SUNDRY NOTICES AND REPORTS ON WELLS

8. Well Name and No. 317459
DELAWARE RANCH 11 14 B2AP F C 1H

Mewbourne Oil Company has an approved APD for the above well. Mewbourne requests approval to make the following changes:

PECOS DISTRICT
DRILLING CONDITIONS OF APPROVAL

Delaware Ranch 11/14 W2AP Fed Com #1H
SL: 185' FNL & 425' FEL, Sec 11
Sec 11
KOP @ 10140'
FTP: 330' FNL & 425' FEL, Sec 11
LP: 587' FNL & 425' FEL, Sec 11
Hard Lines
Sec 14
BHL: 330' FSL & 425' FEL, Sec 14
South(-)/North(+) (2500 usft/in)
West(-)/East(+) (2500 usft/in)

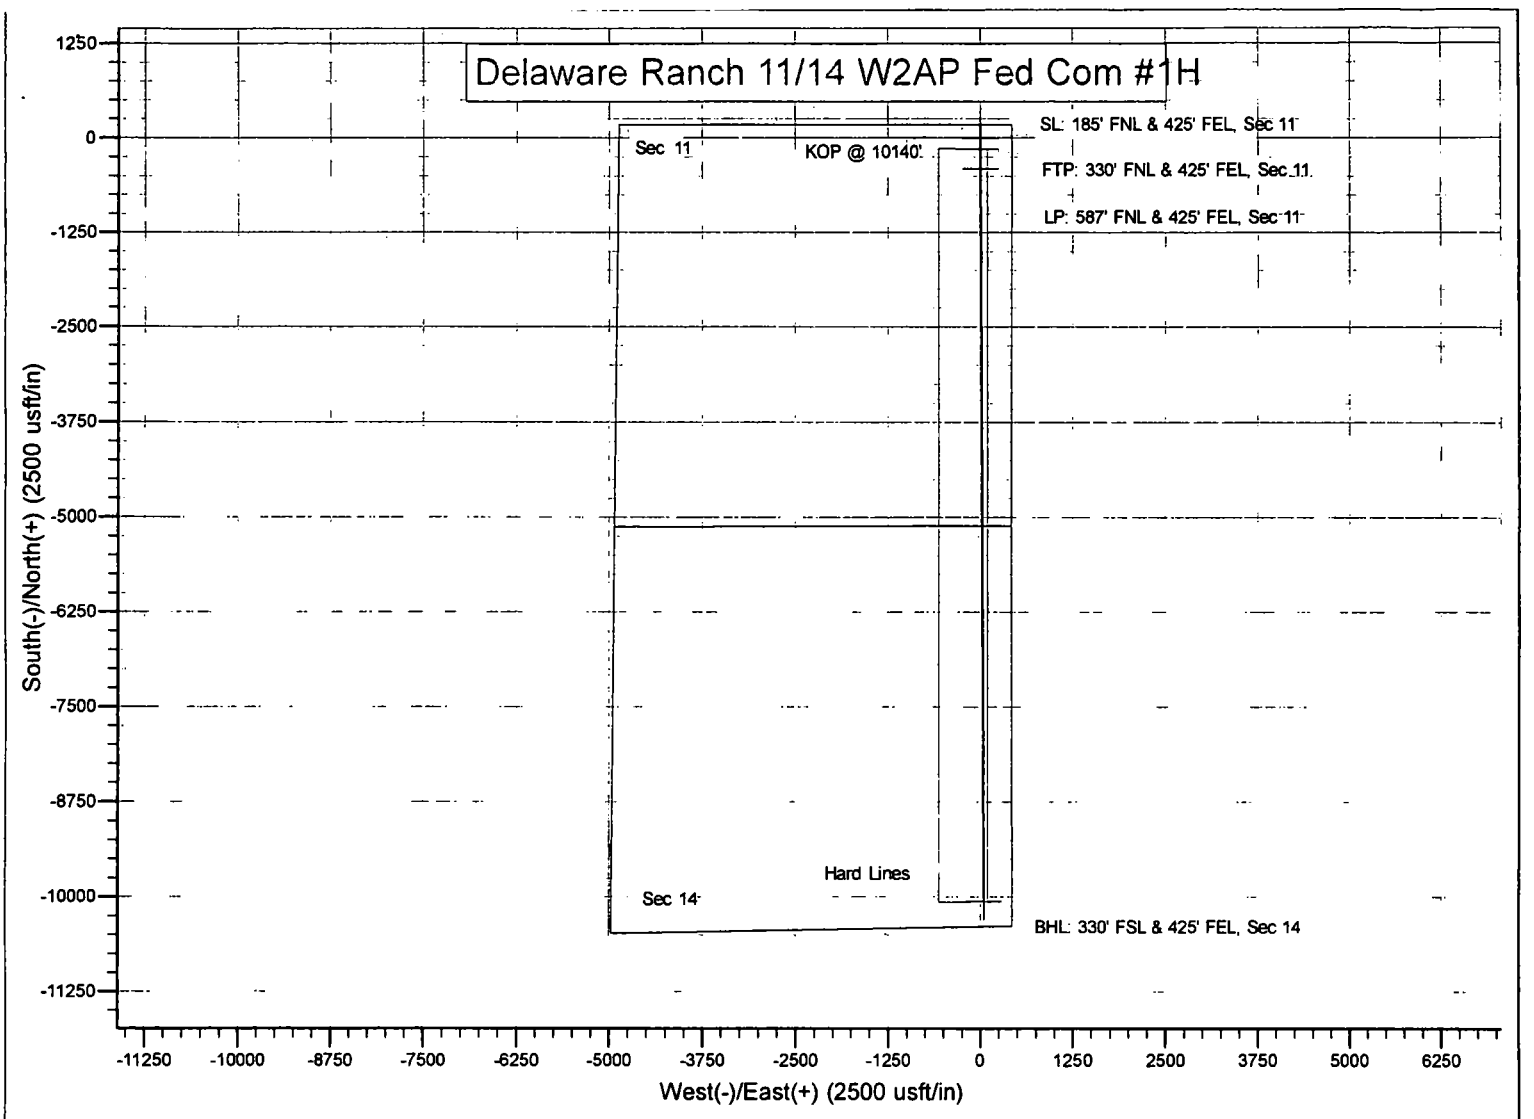
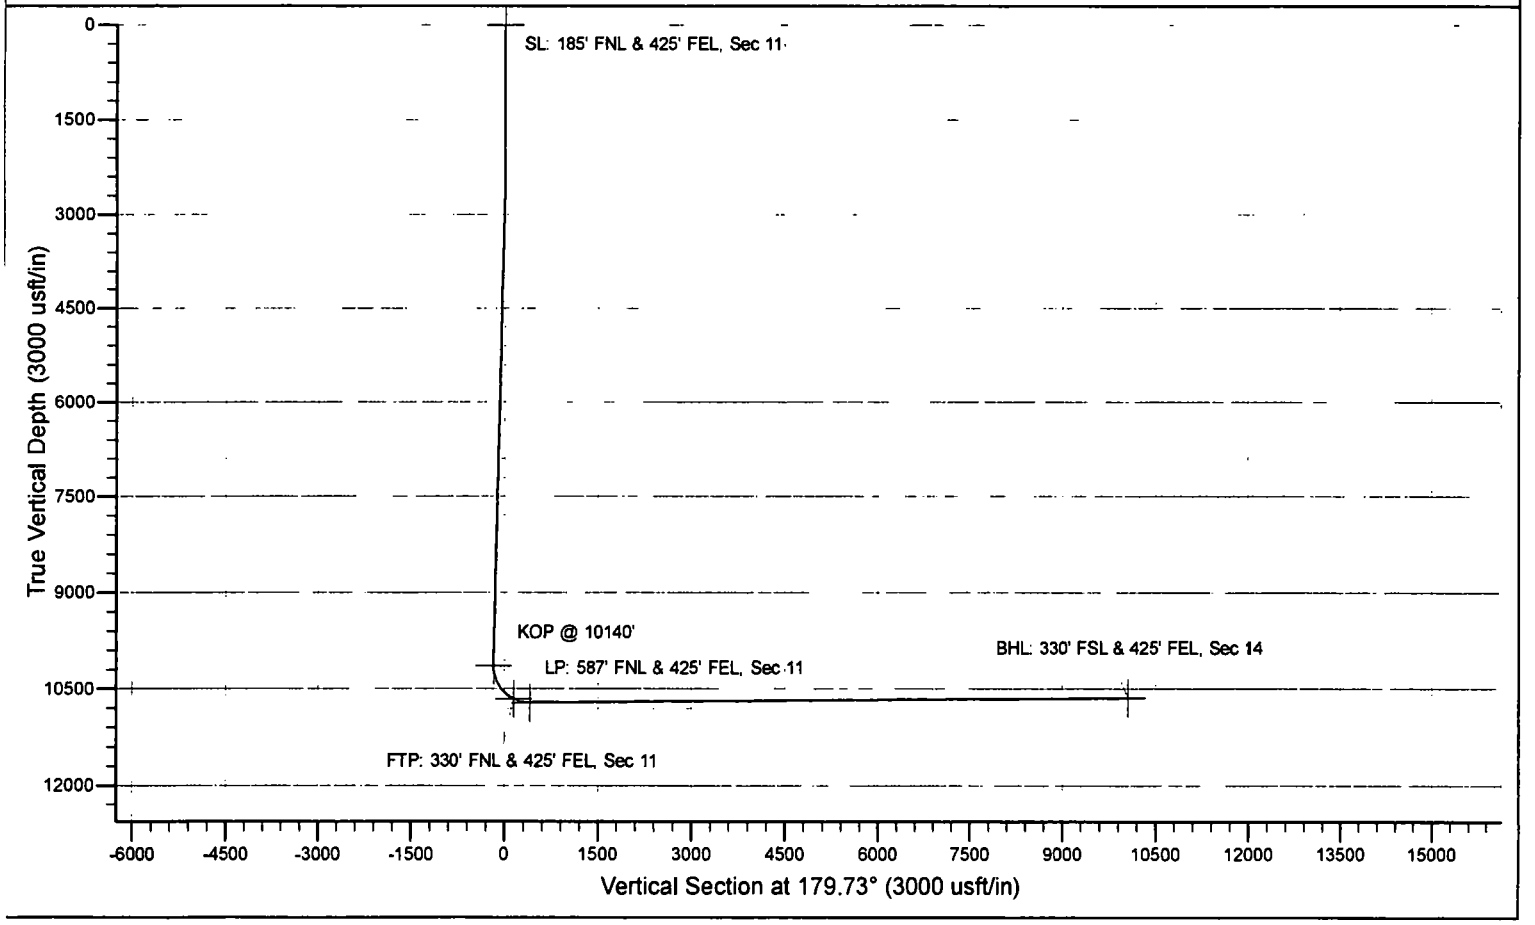
1) Change well name to Delaware Ranch 11/14 W2AP Fed Com #1H. - property 324931
2) Change pool to Purple Sage Wolfcamp 98220 (Gas Well).
3) Change target zone to Wolfcamp & TVD to 10,713'.
4) Change BHL to 330' FSL & 425' FEL, Sec 14, T26S, R28E.
5) Change csg depth and cement to suit new plan.
6) Change wellhead to multi-bowl type wellhead.
